# Road Safety Audit Review

Ferry Road, Charlotte

July 23, 2020

Vermont Agency of Transportation  
Operations & Safety Bureau

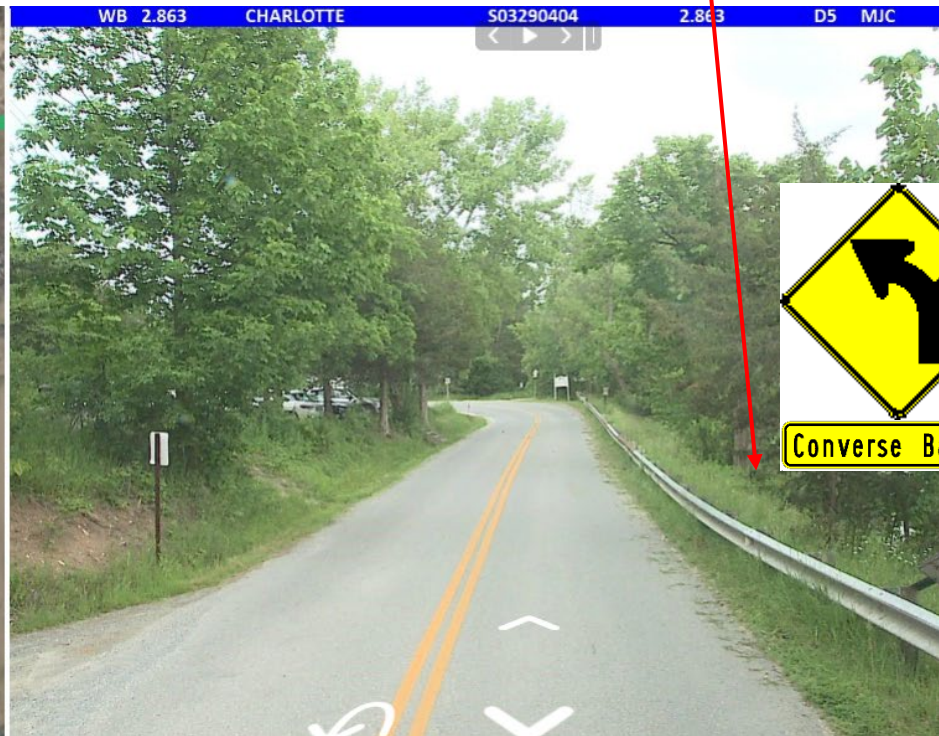
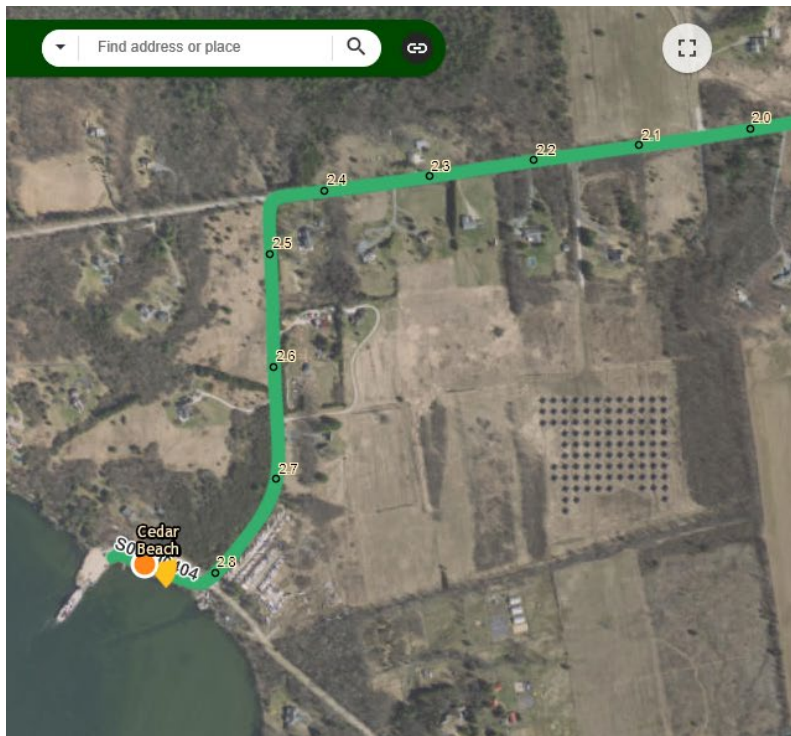
New curve sign with side road (W1-10 L) and Converse Bay Rd street name plaque (W16-8P). Approximately 200 ft west of Converse Bay Rd. Install on two posts.

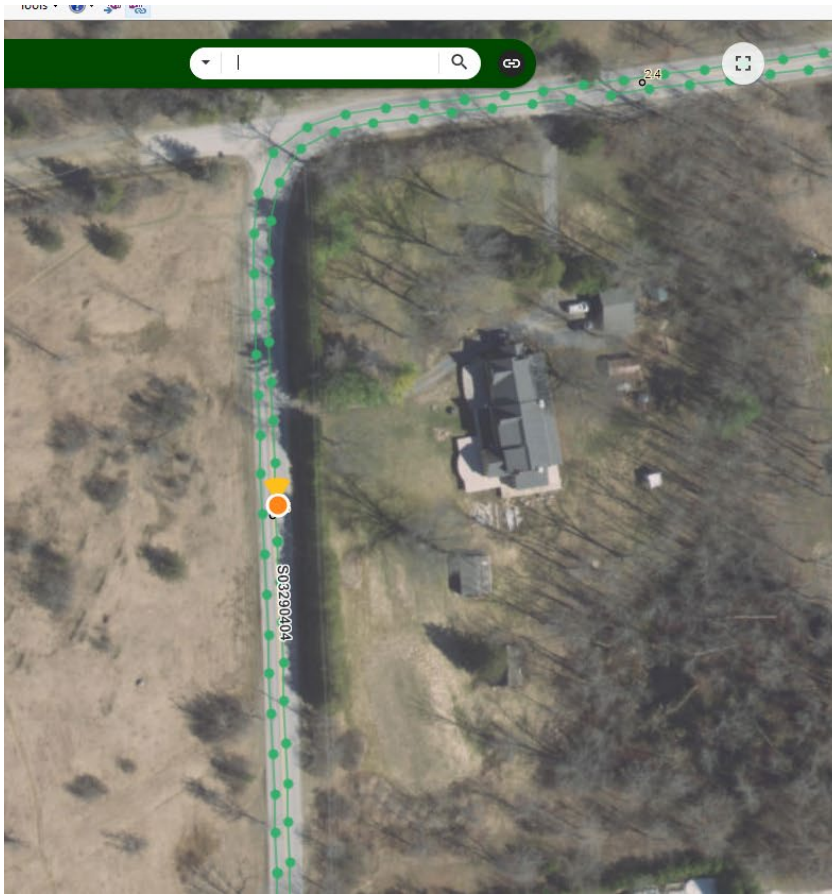
Replace the curve sign with a modified turn sign with a side road and a 15 mph advisory speed plaque (13-1P), and a Wings Point Rd street name plaque (W16-8P)

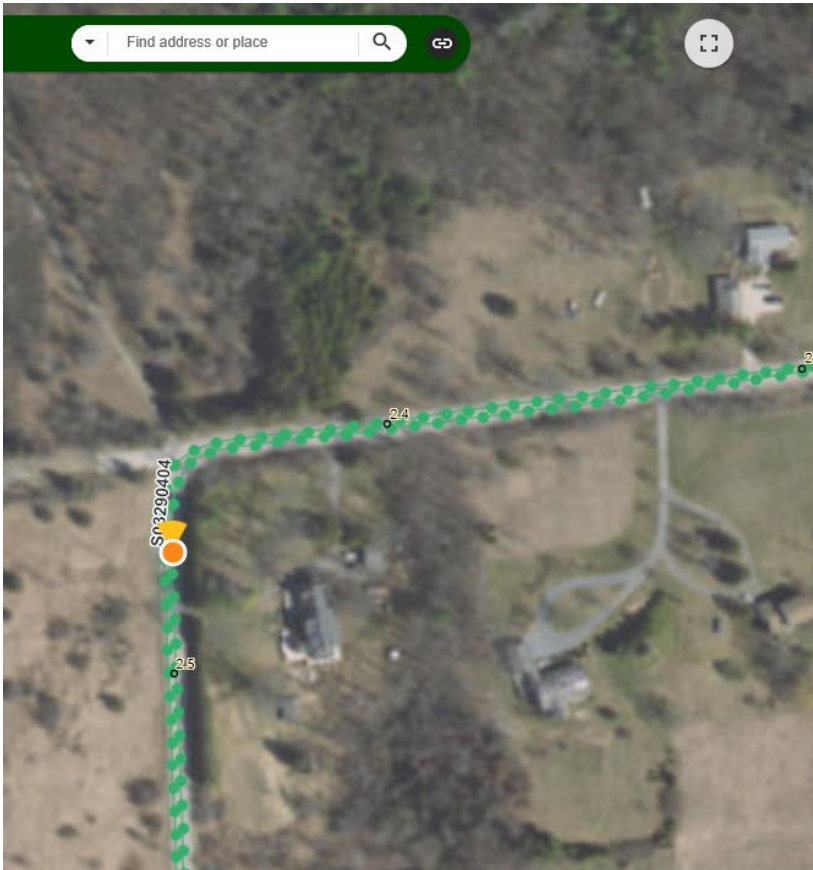
Remove the existing large arrow in the red circle and install a new large arrow (W1-6) on the other side of the drive (where the arrow is pointing)

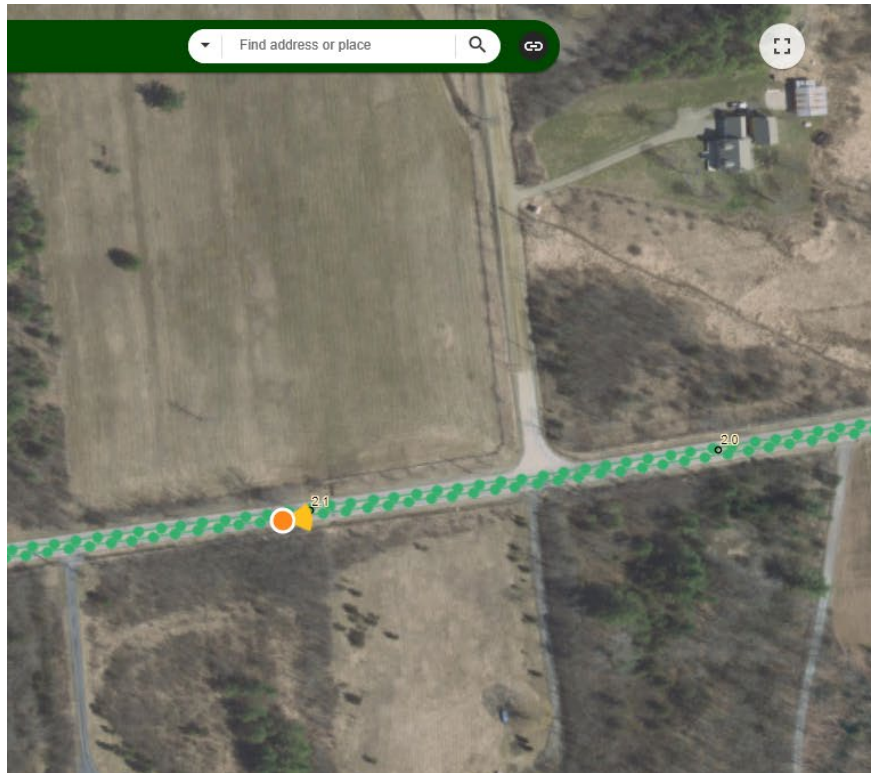
Install a side road intersection sign (W2-2) with a Whalley Rd street name plaque (W16-8P) 300 ft east of Whalley Rd

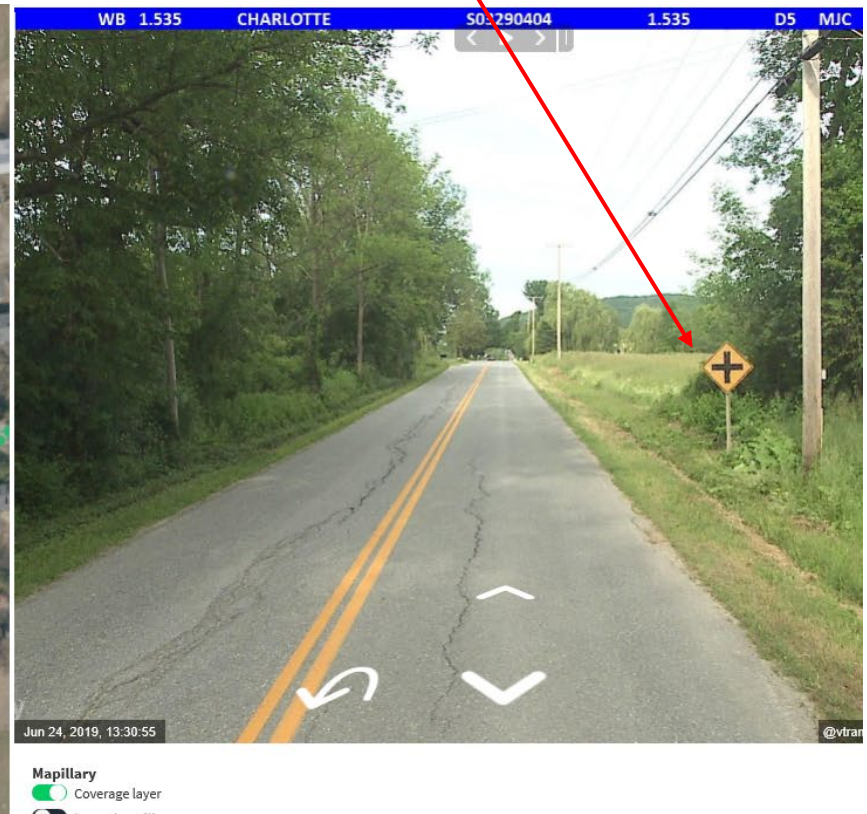
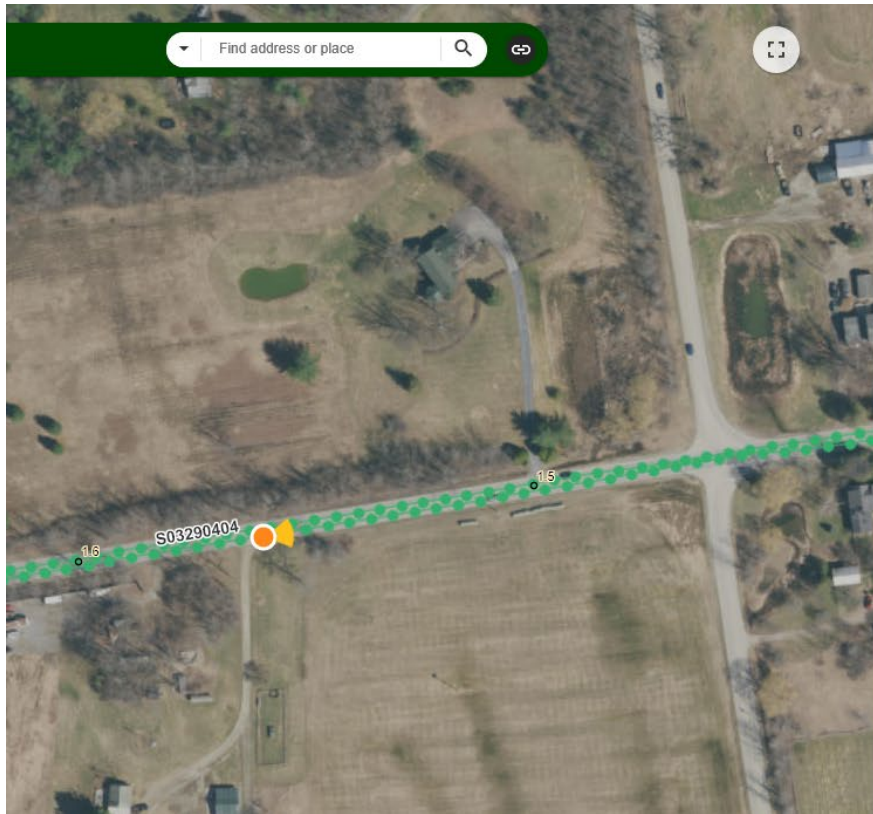
Remove the existing intersection sign for eastbound Lake Rd intersection

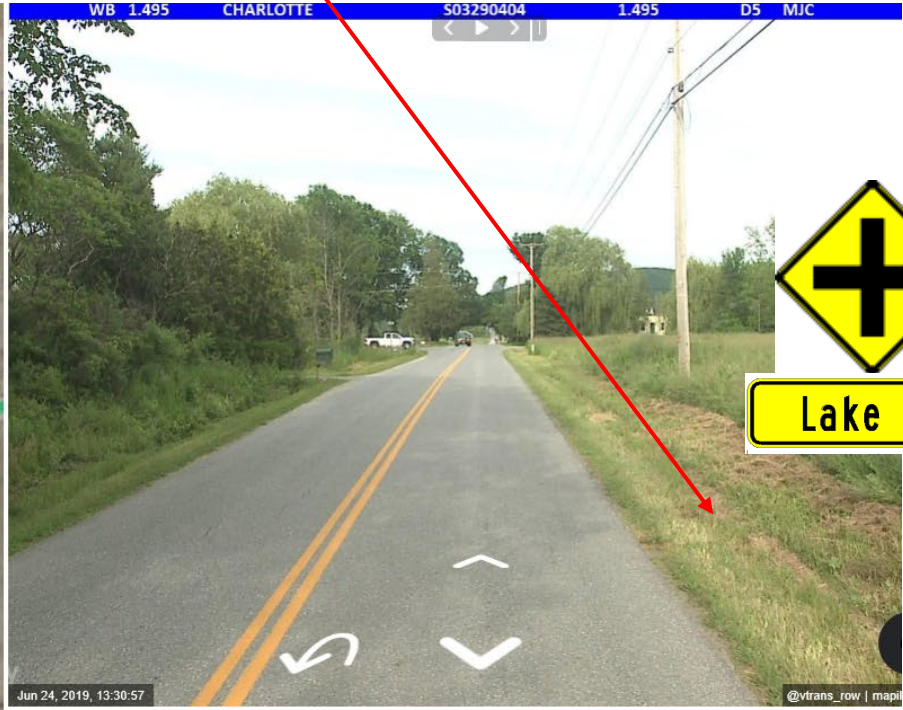
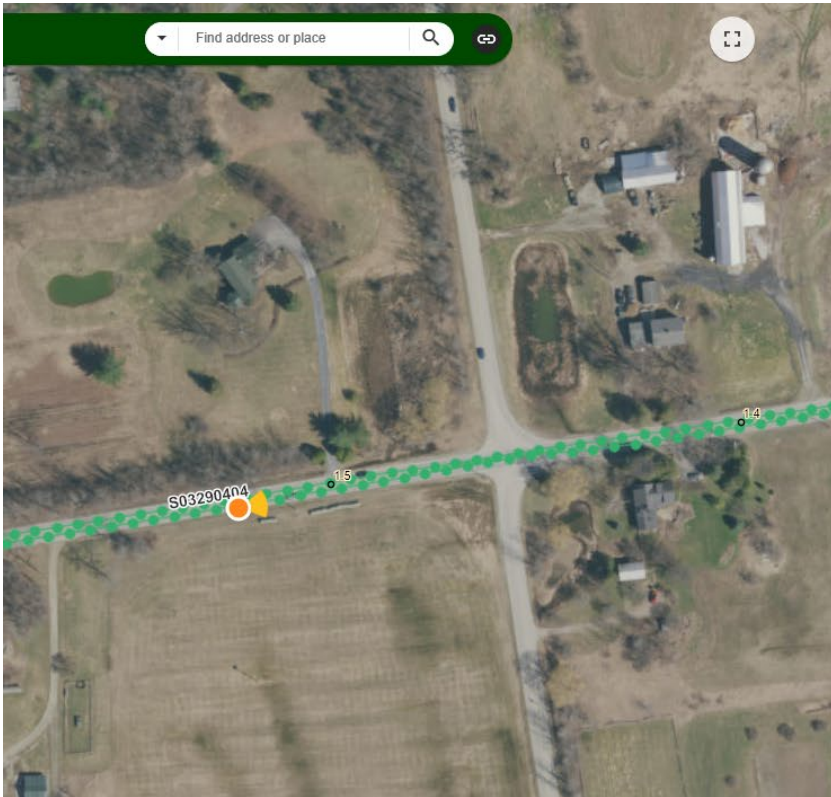
Install an intersection sign (W2-1) with a Lake Rd street name plaque (W16-8P) about 300 ft east of Lake Rd
